**To:** Shane Lippard, Right Angle Engineering  
**From:** Brian Chambers, Senior Planner; 910.342.2782  
**CC:** File;  
**Date:** 11/22/2022  
**Re:** The Block on Front TRC Rev. 3

Engineering has reviewed the plans for The Block on Front project submitted November 7, 2022, and have the following comments:

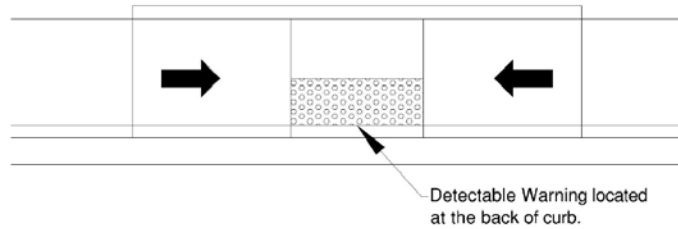
1. Ramps for handicap parking spaces are not provided in accordance with City or ADA standards since flare type ramps will not be able to provide sufficient landing on 4' sidewalk. Instead provide parallel ramps. Reference image below. Refer ADA standards for further reference.
